MFN 05-127

Subject: **NEDO-33083-A, "TRACG Application for ESBWR," October 2005
(TAC # MC8168)**

TRACG Application for ESBWR

Figure
3.7.2.5

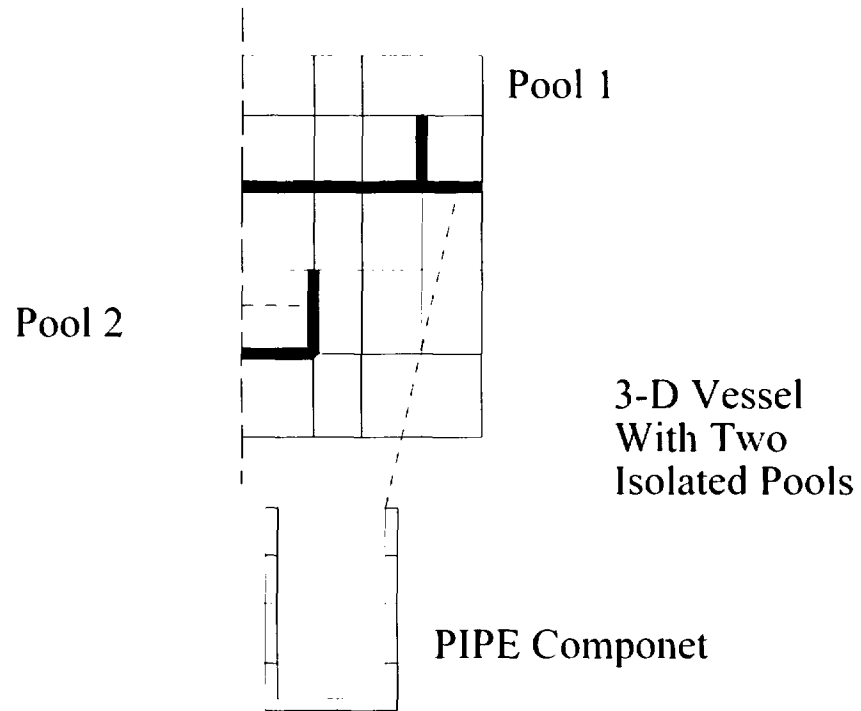
In order to verify this code feature, a TRACG test problem was set up to examine the flow through a "U" tube with two pools connecting with each end of the PIPE component. As shown in Figure 3.7.2.5, in Section 8 of this report, a 3-D VESSEL component has two pools. One is located at level 2 and ring 1; another is located at level 4 and ring 4. Both pools have the same initial water level and cell center pressure. The top of level 3 is assumed sealed with a zero axial flow area. The two pools are connected by a 5 cell "U" tube. The split of the 3-D vessel component into two volumes with two identical pools should have zero flow rate through the connecting TRACG 1-D PIPE component. The TRACG calculation results show that the flow through the 1-D PIPE is very close to zero. The two pools have the same actual elevations with respect to the "U" tube PIPE component, although they appear to be at different elevations within the 3-D VESSEL component. Therefore, the ESBWR ECCS model preserves the gravity head and the actual elevations with the 1-D component solver.

Figure 3.7.2.10 TRACE Fuel Channel Model.

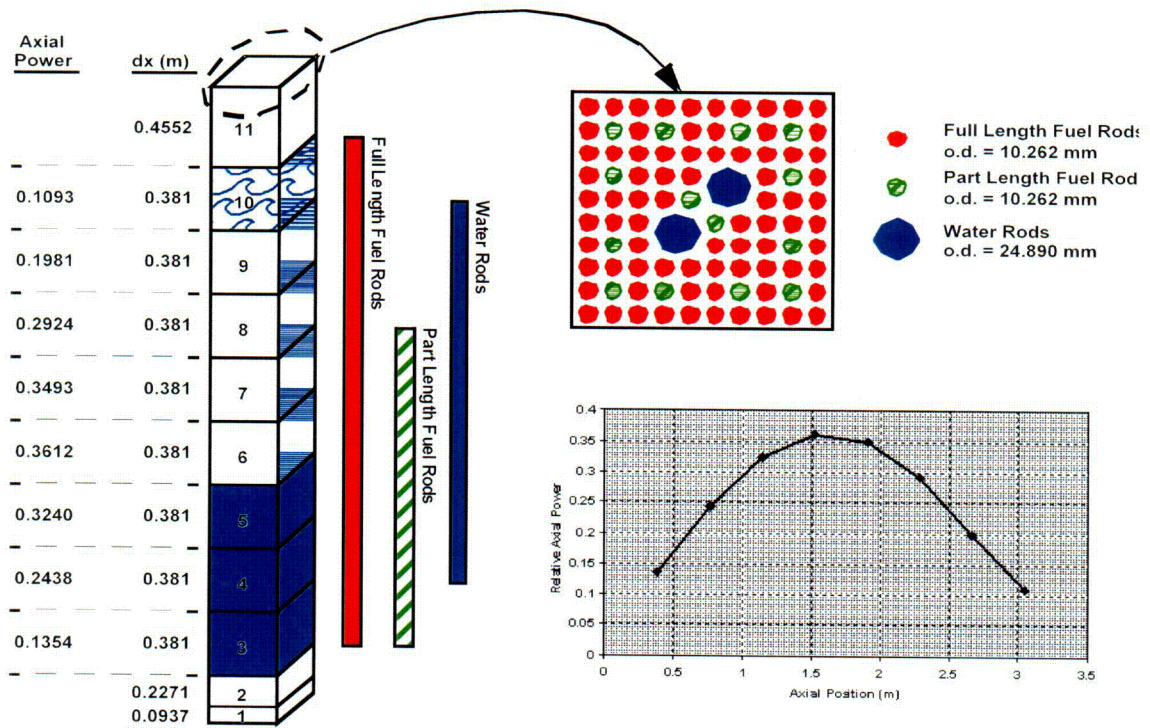
]]. Each CHAN component is based on a GE-12 fuel bundle and is modeled using [[]] axial cells, [[]] of which correspond to the active fuel region. This model is illustrated in Figure 3.7.2.10 in the figures section of this report. Both the water rods and part length fuel rods are explicitly modeled using the TRACE advanced fuel channel model.

The nominal power for the ESBWR core is 4000 MW, and the TRACE model uses point kinetics with reactivity feedback to calculate the core power. The axial power distribution used for each CHAN component is shown above in Figure 3.7.2.10 in Section 8 of this report. The power component modeled in TRACE also includes a scram table and decay heat data. The scram table is designed to insert all of the negative reactivity (-0.2175 k/k) into the core over a period of 2.8 seconds following receipt of the scram signal.

Figure 3.7.2.11 TRACE ESBWR Main Steam Line.

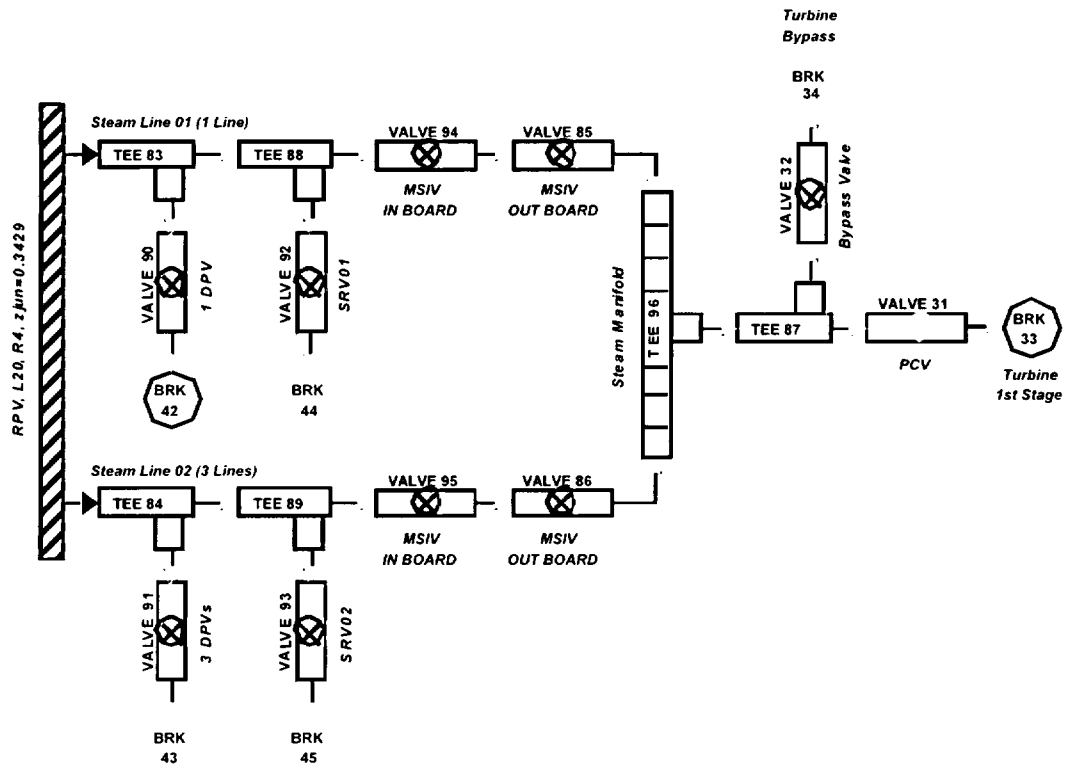
The steam lines themselves are modeled with two trains, one representing one line and one representing three lines, as illustrated in Figure 3.7.2.11 in Section 8 of this report. TEE 83 and 84 connect to the vessel and correspond to the steam inlet, and both include a branch for 1 DPV and 3 DPVs, respectively. Connecting to TEE 83 and 84 are TEE 88 and 89, respectively, both of which include a branch for the SRVs. Connecting to TEE 88 and 89 are VALVE 94 and 95, respectively, which represent the "in board" MSIV and are followed by the

Figure 3.7.2.12 TRACE ESBWR Containment Model

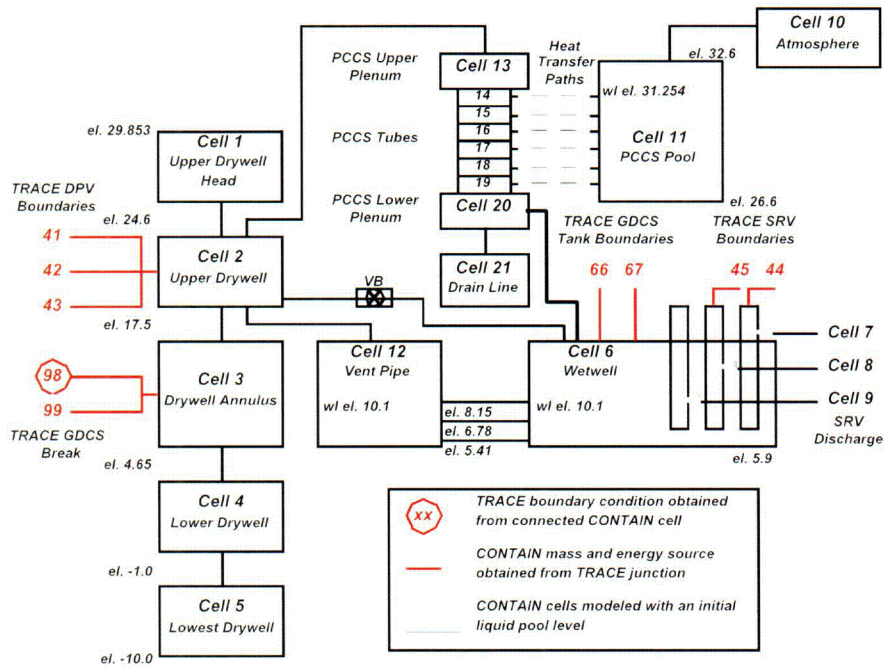
The CONTAIN model used for the TRACE/CONTAIN LOCA analysis was developed based on the model used in the CONTAIN stand-alone analysis described in Section 3.7.2.2 of this report. The nodalization of the model with elevations is shown in Figure 3.7.2.12 in Section 8 of this report. There were 21 cells used to model the ESBWR containment building, five of which were used for the drywell. One cell each was used for the PCCS upper and lower plenum, and six cells were used for the PCCS tubes. The PCCS pool, PCCS drain line, wetwell, and wetwell vent pipes were modeled with one cell each. An additional cell (Cell 10) was used to provide the atmospheric condition for the PCCS pool.

The connections to the TRACE model are highlighted in red in Figure 3.7.2.12 in Section 8 of this report. BREAKs 41-43, which represent the DPV boundaries, are connected to the upper drywell of the CONTAIN model (Cell 2). BREAKs 44 and 45, which represent the SRV boundaries, connect to the SRV discharge pipes modeled by Cell 7 and Cell 8, respectively. BREAKs 66 and 67, which represent the wetwell boundary for the GDSC tanks, are both connected to the wetwell modeled by Cell 6. And lastly, BREAKs 98 and 99, which represent the GDLB, are both connected to the portion of the drywell modeled with Cell 3.

Figure 3.7.2.15 GDCS Line Break Mass Flow Rate.

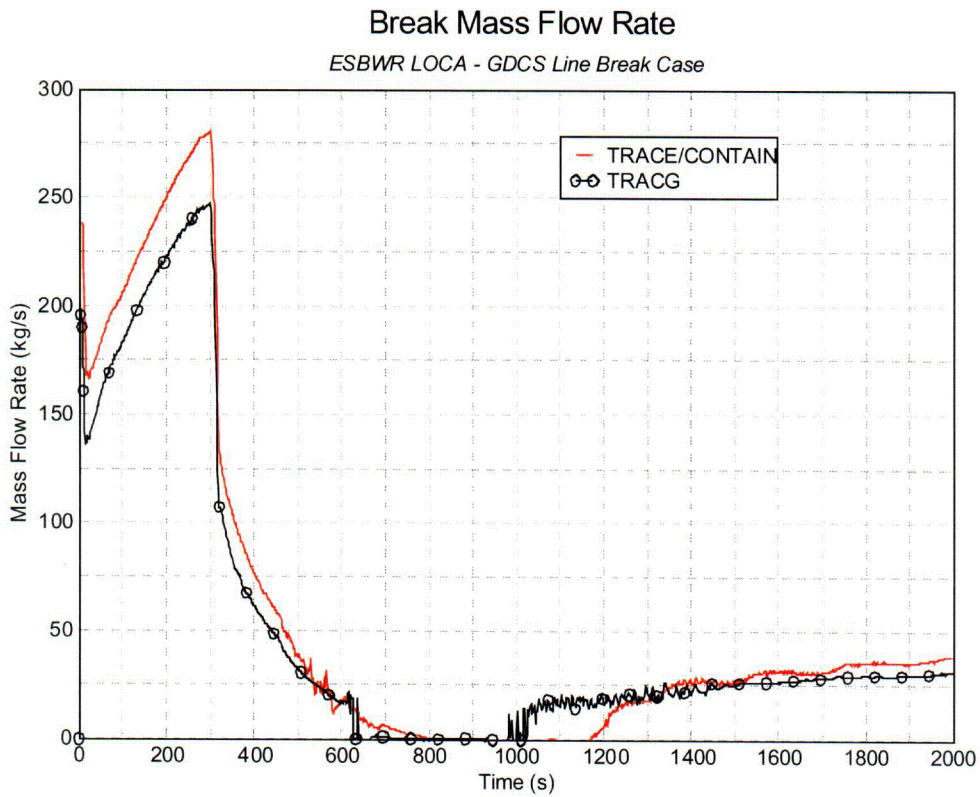
The mass flow rate through the GDLB is shown in Figure 3.7.2.15. Both codes predict the same trend of the mass flow rate. At the beginning of the transient, the mass flow rate increases due to increasing dome pressure. After the ADS opens all of the SRVs and DPVs, the break flow rate drops. From 650 to 950 seconds, both codes calculate very small mass flow through the break due to the pressure equalization between the vessel and the drywell. After 1200 seconds the flow from the GDSC spills through the break, and the calculated mass flow rates by both codes are almost identical.

Figure 3.7.2.16 GDCS Line Break Dome Pressure.

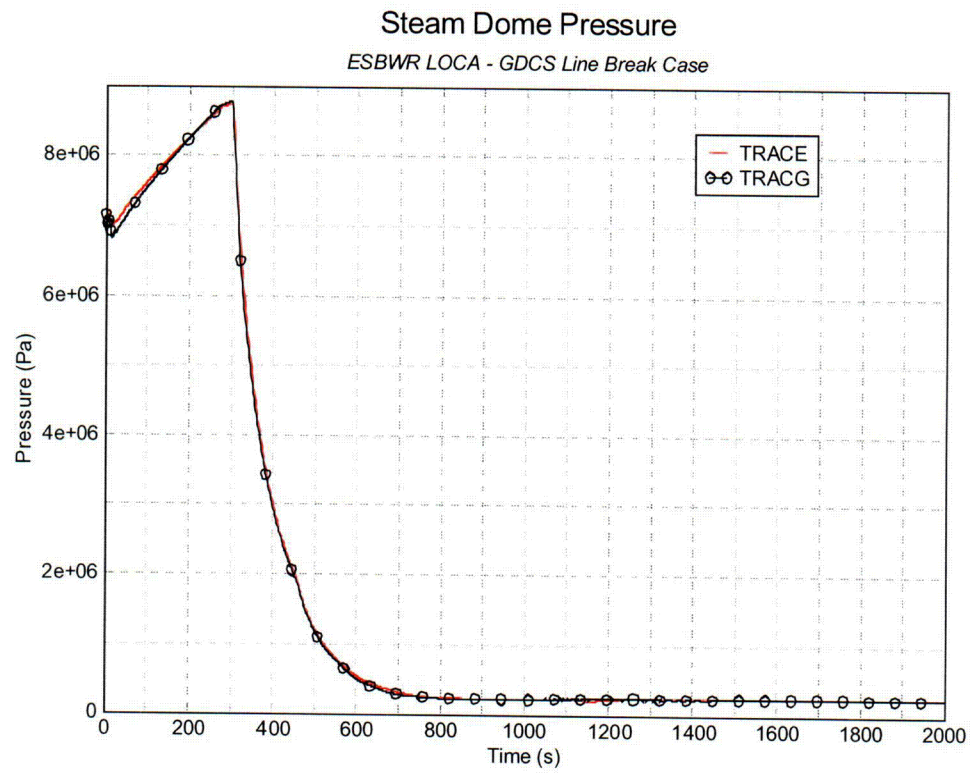
Figure 3.7.2.16 shows the steam dome pressure calculated by the TRACG and TRACE/CONTAIN codes. Both codes predict the initial pressure rise due to the MSIV closure after the break. The dome pressure rises until the downcomer L1 trip activates the ADS system. Both the TRACE/CONTAIN and the TRACG predictions reach the L1 trip about 310 seconds into the transient. After the ADS activates, both codes predict the rapid depressurization and a nearly identical long term pressure trend.

Figure 3.7.2.19 Drywell Total Pressure and Non-Condensable Partial Pressure.

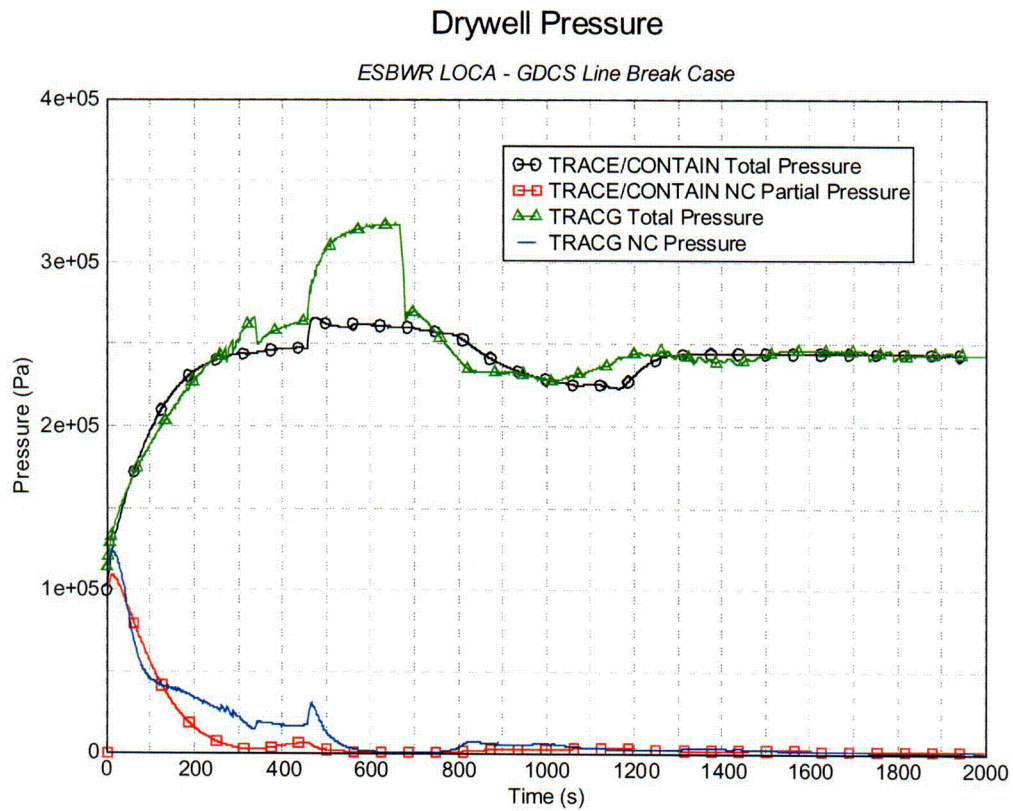
The upper drywell total pressure and the noncondensable partial pressure are shown in Figure 3.7.2.19. Both codes predict that most of the noncondensibles in the drywell are purged into the wetwell during the early blowdown. The same trend of pressure stabilization is observed. The total pressure difference between the TRACG and TRACE/CONTAIN results is about 0.75 bar, with the TRACG code predicting a higher pressure at about 670 seconds. The difference appears to be caused by different nodalization schemes used for the two codes.

Figure 3.7.2.20 Wetwell Total Pressure and Non-Condensable Partial Pressure.

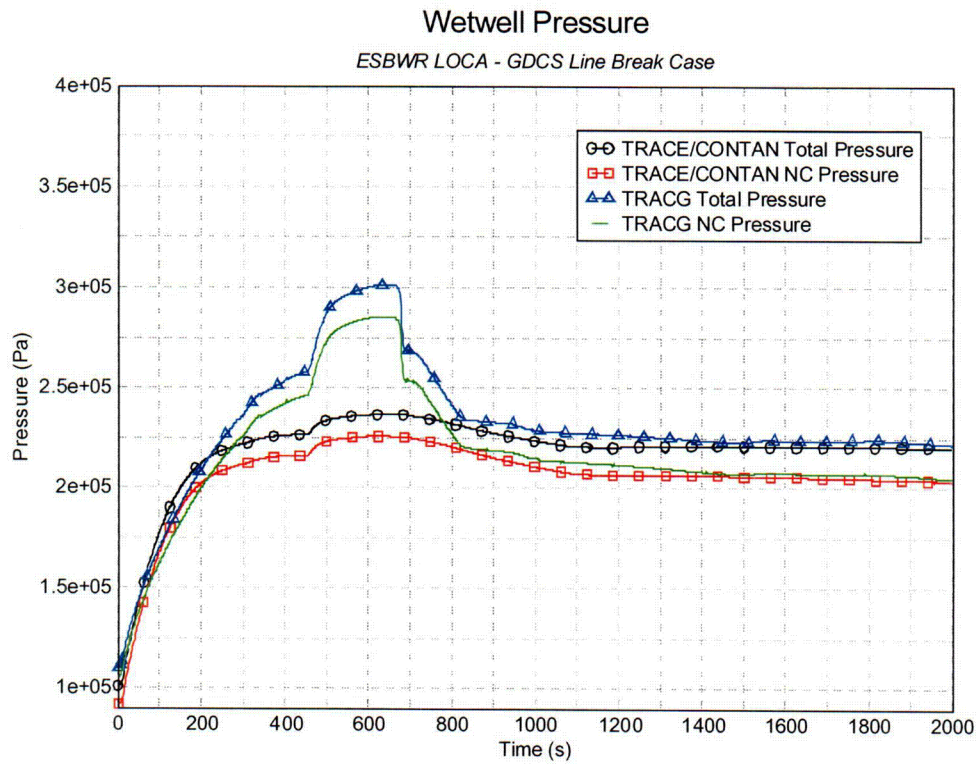
Figure 3.7.2.20, indicates that the total pressure in the wetwell increases primarily due to the transfer of noncondensibles through the drywell to wetwell vents. The dominant mass transfer through the wetwell liquid is the noncondensable gases which accumulate in the wetwell air space. The TRACG code predicts higher pressure (by about 0.75 bar) at about 670 seconds.

3.7.2.21 Drywell and Wetwell Atmosphere Temperature.

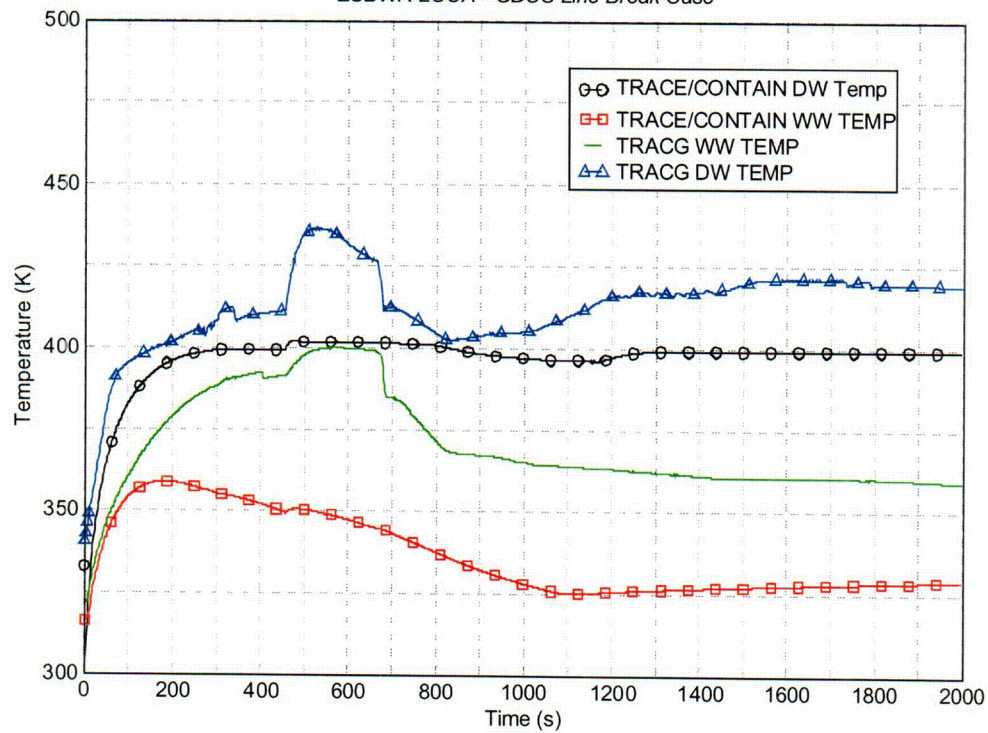
The difference in these two codes is demonstrated clearly in the calculated drywell and wetwell air space temperature, shown in Figure 3.7.2.21. TRACG predicts a 50 K (90 °F) degree higher wetwell air space temperature than does TRACE/CONTAIN. The major difference may be due to the code internal physics packages, e.g, for calculating interfacial heat transfer and pool water surface condensation. Also contributing to the difference is the nodalization schemes used for the two calculations. While the TRACG nodalization partitions the wetwell air space into [[]] nodes, the TRACE/CONTAIN nodalization represents the wetwell by one node. TRACG calculates different air space temperature in different nodes. Although the temperature distributions in the containment are different, the pressure distributions in different containment compartments is similar.

Figure 3.7.2.22 GDCS Mass Flow Rate

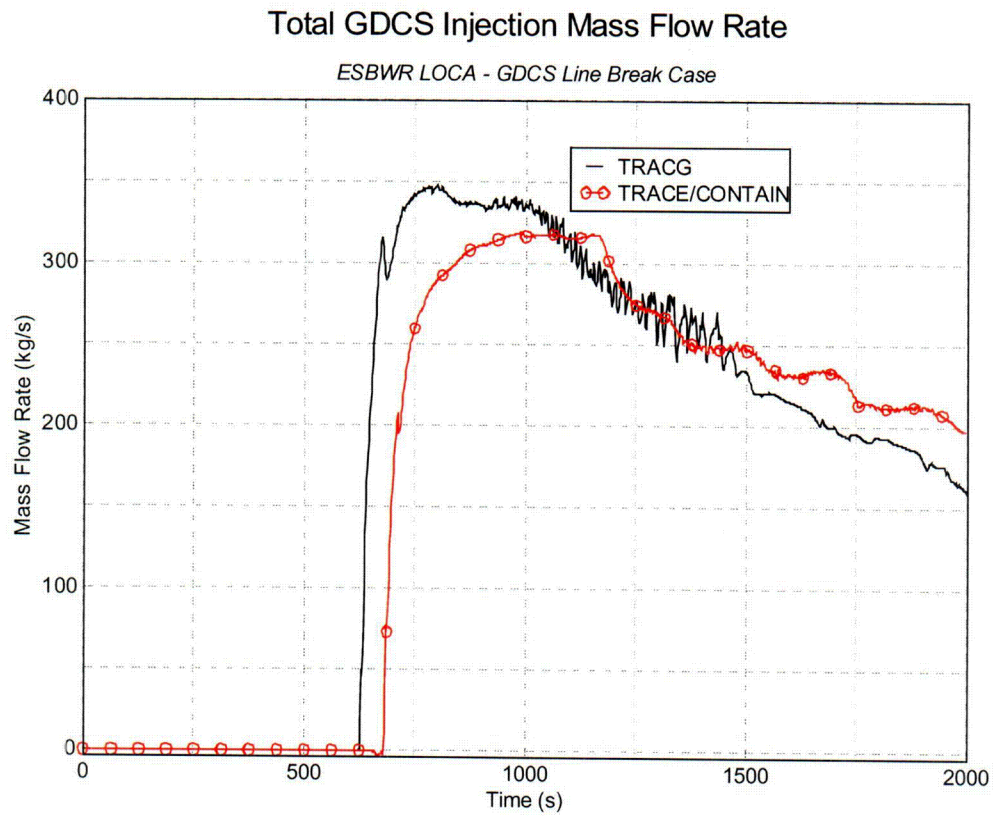
A significant feature of the ESBWR ECCS design is the use of a gravity driven cooling system. Figure 3.7.2.22 shows the total GDCS injection mass flow rate. The magnitude and the trend of the TRACG and TRACE predictions are almost identical, with the exception of a shift in the timing of the injection. This timing difference is caused by the different wetwell pressure, confirming not only that the ESBWR gravity driven ECCS system can be expected to function as intended, but also that the TRACG code is capable of realistically modeling the ECCS performance during the GDCS LOCA.
